# LAUREL LAKE VILLAS

## HUDSON, OHIO

**AHBR DESIGN REVIEW**  
**MAY 27TH, 2026**

# STAFF COMMENTS 2026

# VILLA 5 – REVISED ELEVATIONS

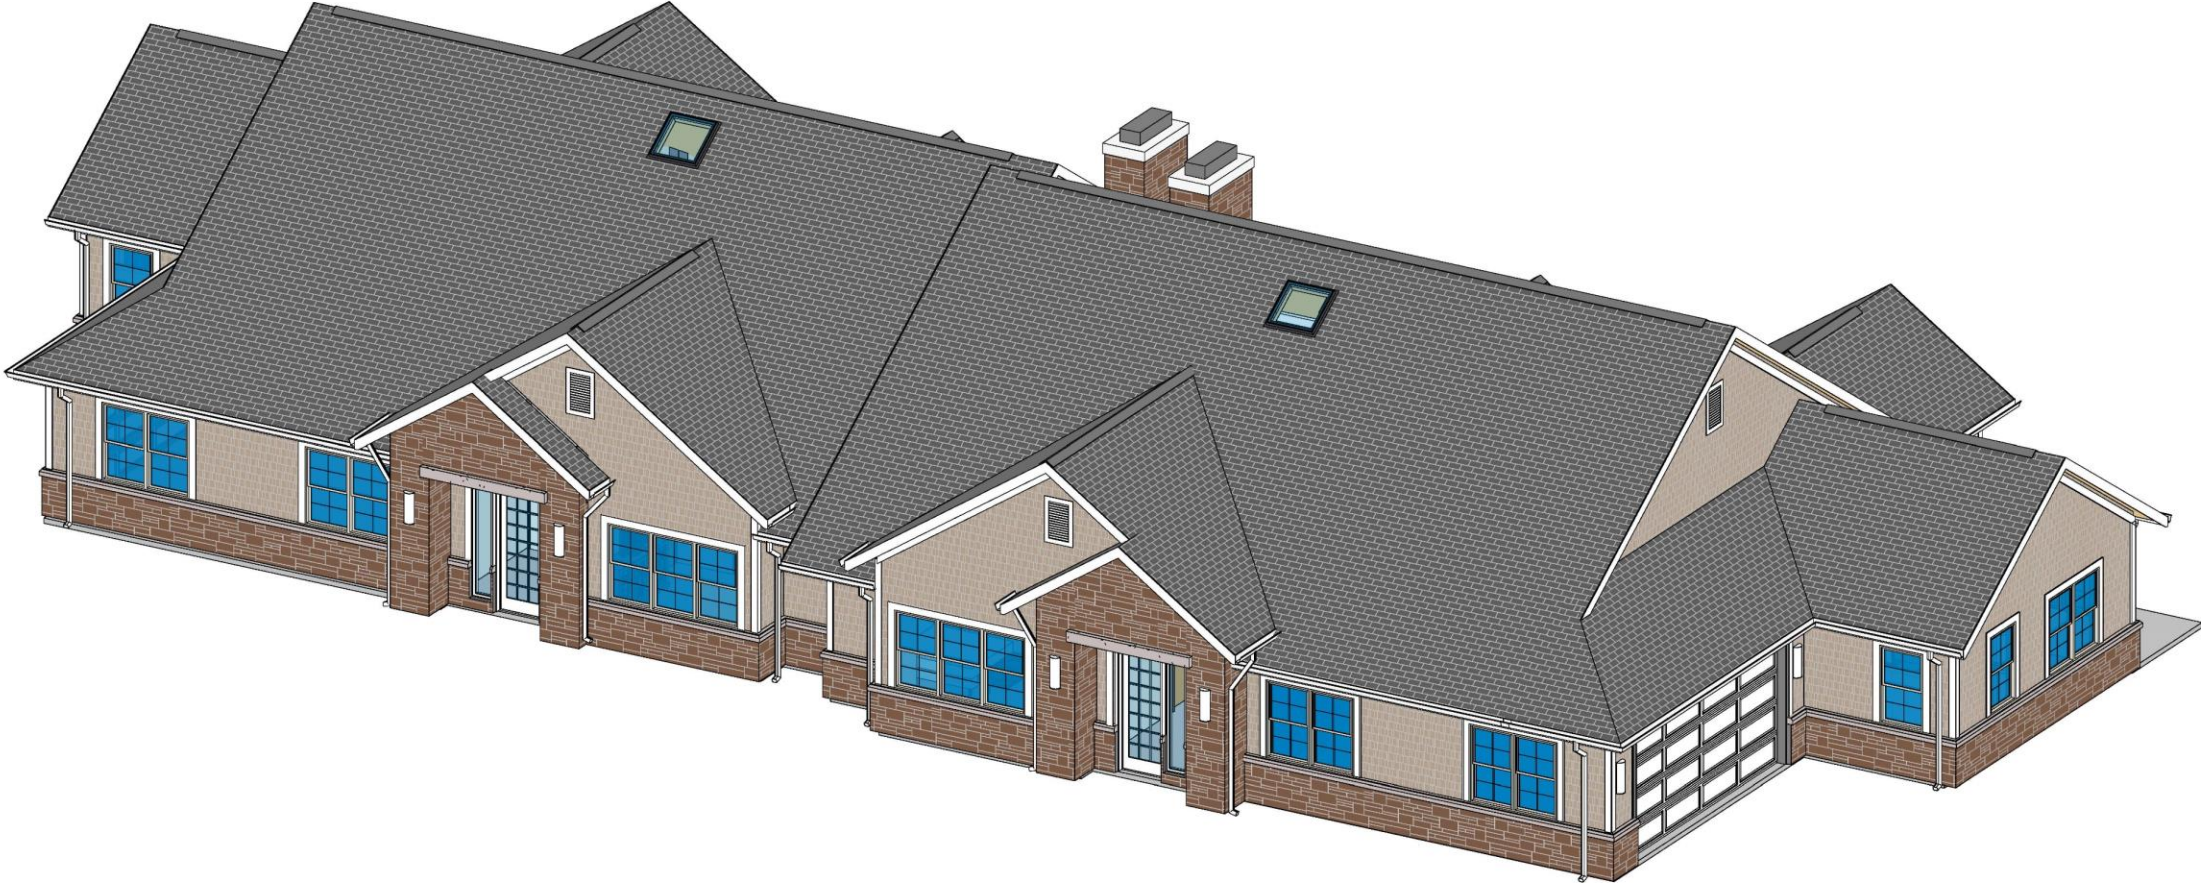
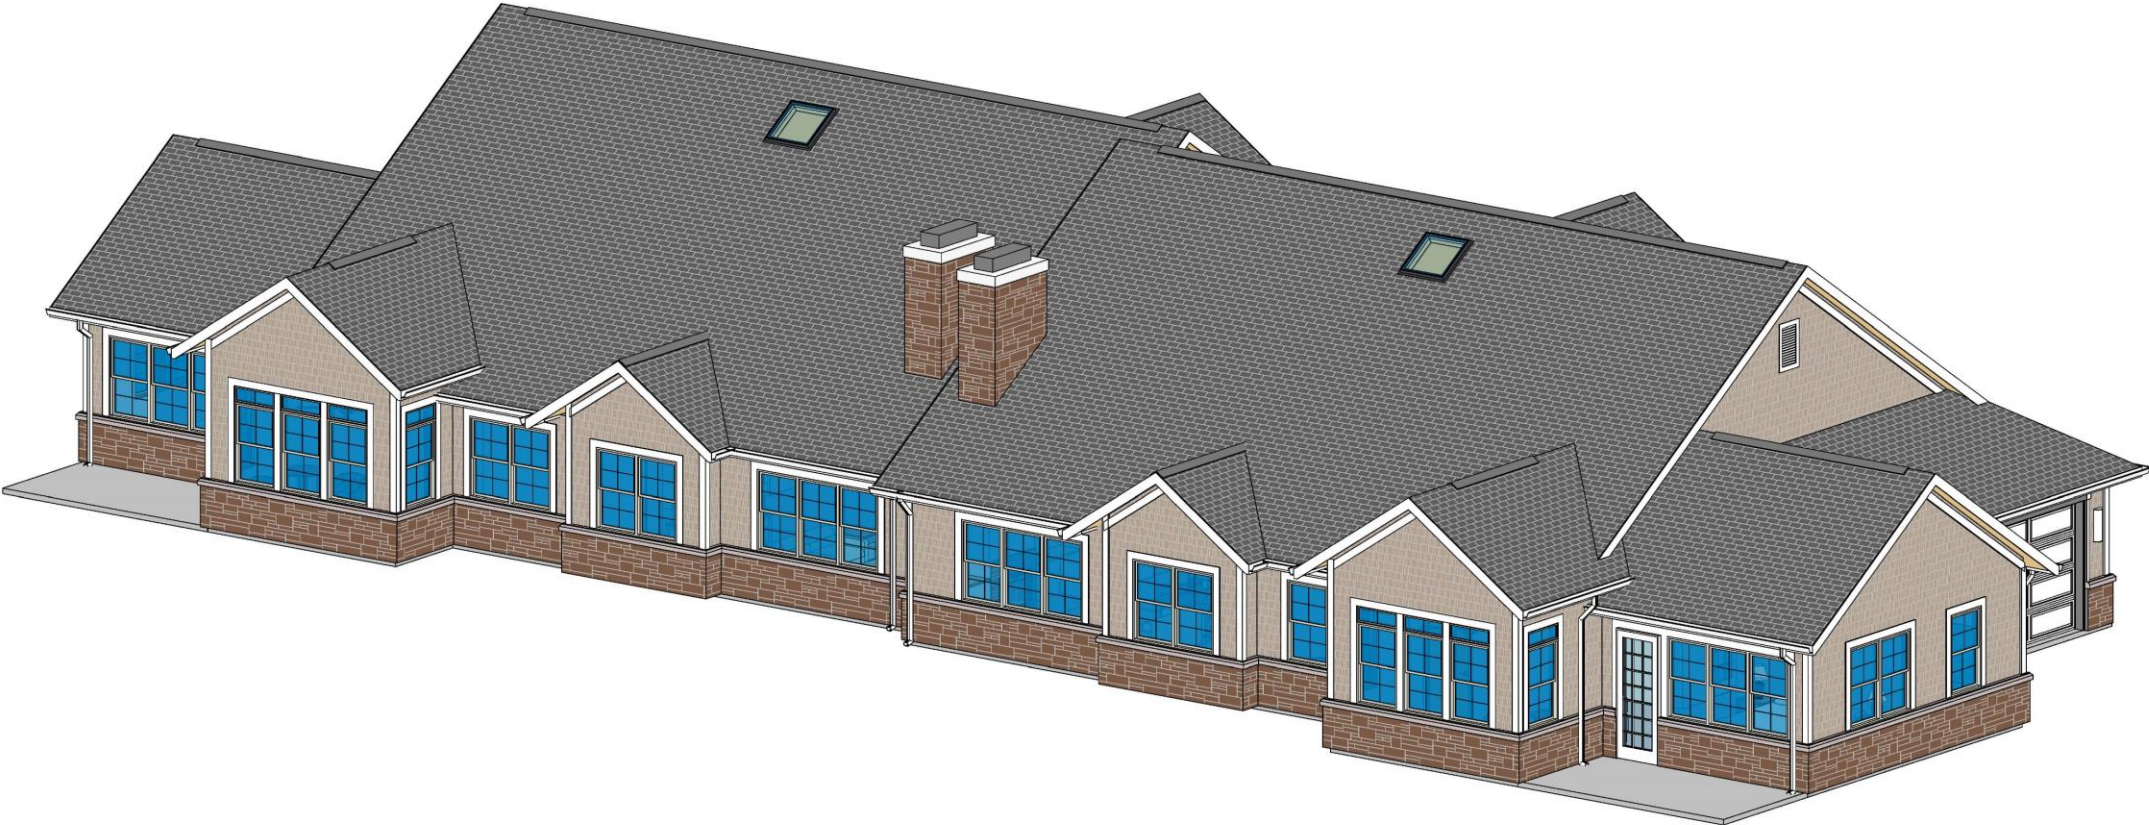
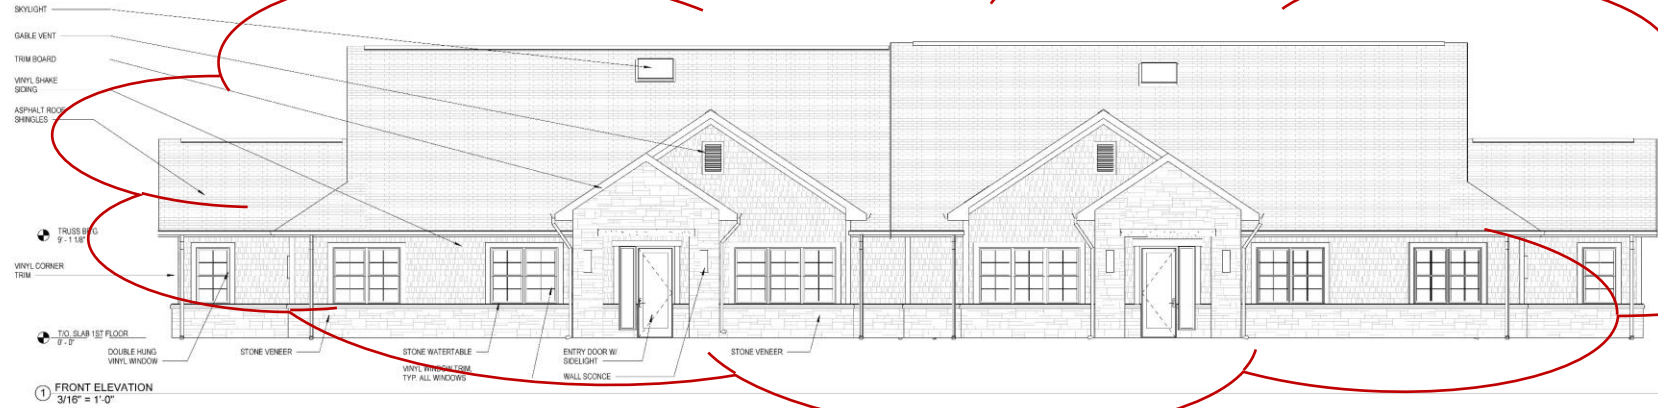
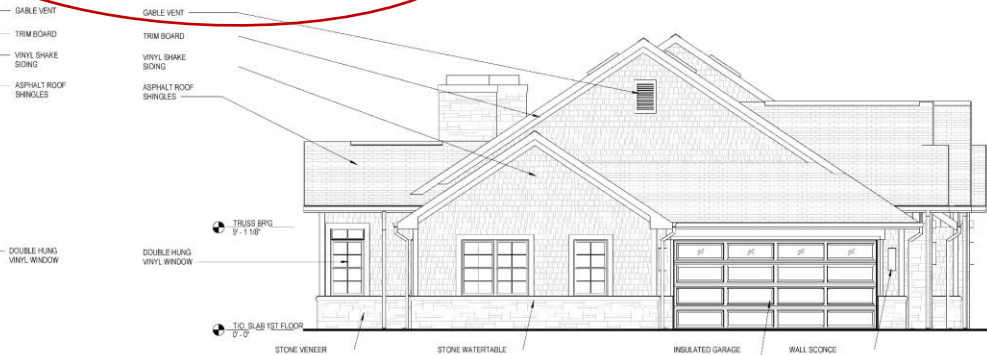
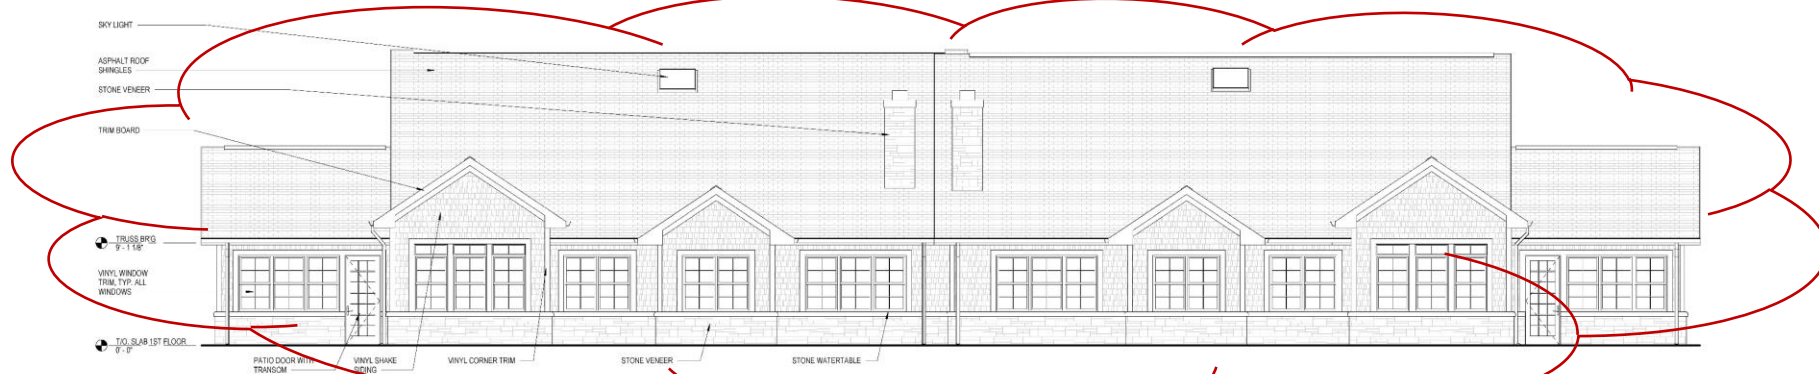
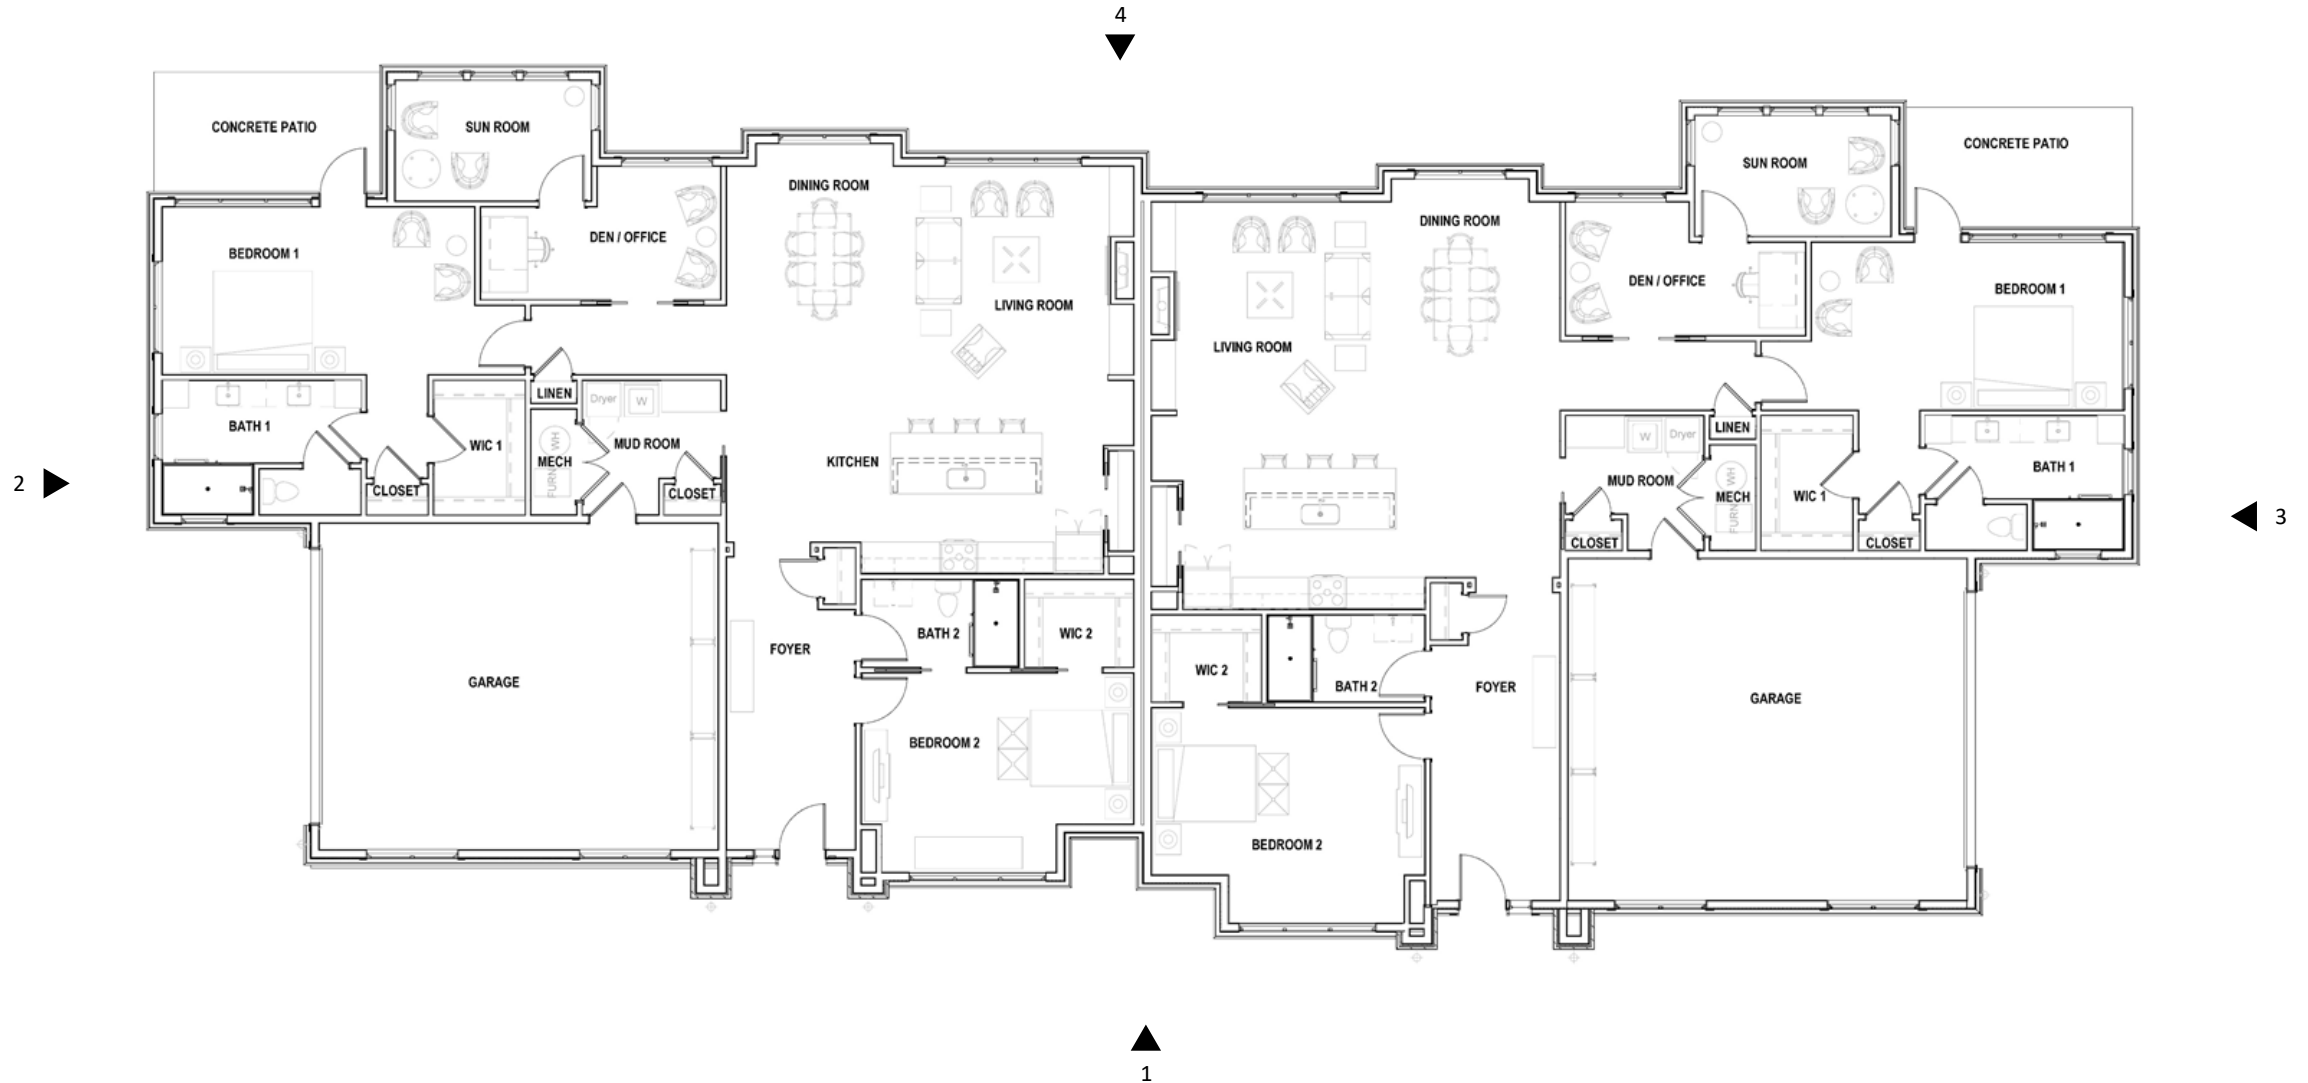
1. Section IV-3 (b)(3) – Forward facing garages.
2. Section IV-3(g)(2) – 5’ projections treated as wings
3. Section III-1(g)(3) – Sunroom foundation material.
4. Section IV-3(f)(1) – Consistent detail applied throughout
5. Section IV-3(c) – Roof to be same shape as main body.
6. Section III-1(g)(3) – Sunroom foundation material.
7. Window trim – Consistent on all elevations.

# CASCADE, VILLA 8 & 9 – DESIGN OPTIONS

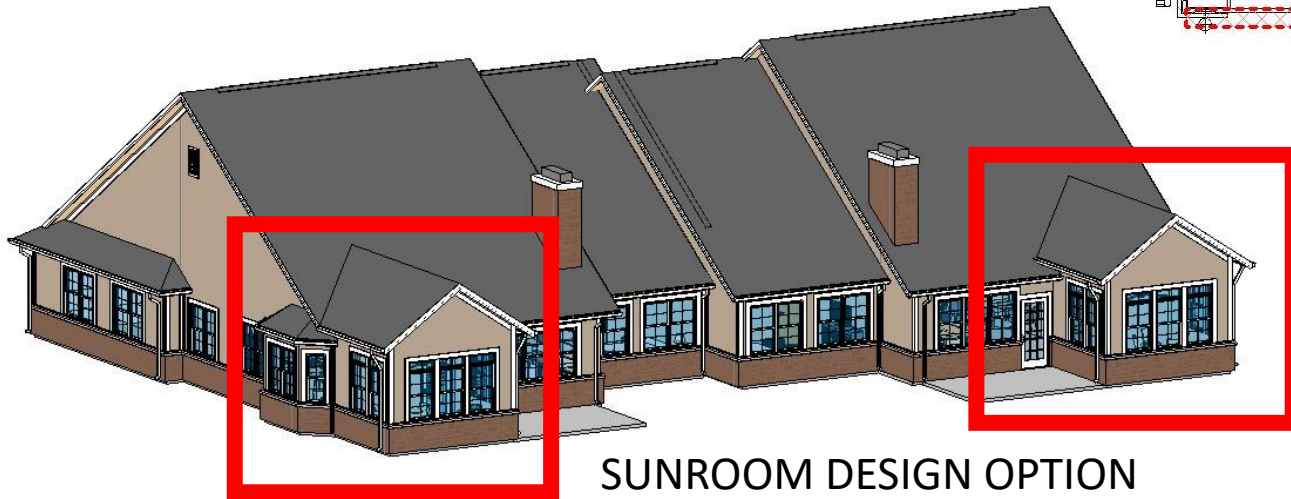
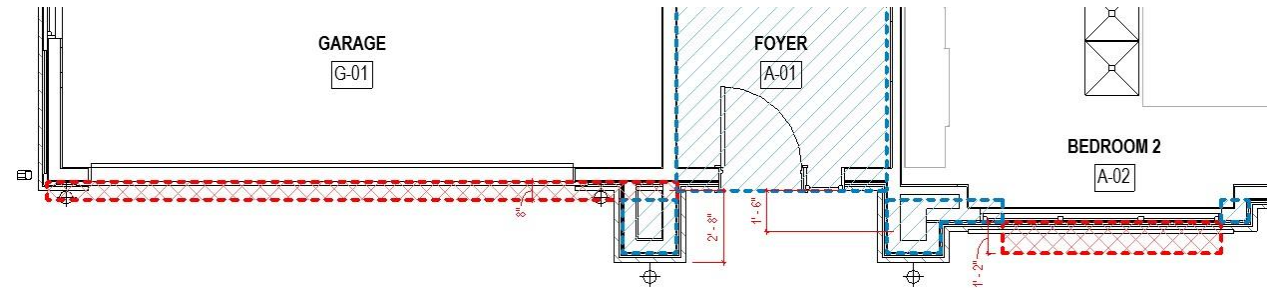
1. Section IV-3 (b)(3) – Forward facing garages.
2. Section IV-3 (b)(2) – Front Faceoff main body is 18” in front of all wings.
3. Section III-1(d)(5) – Fenestration every 12’
4. Section IV-3(c) – Roof to be same shape as main body.
5. Section III-1(g)(3) – Sunroom foundation material.
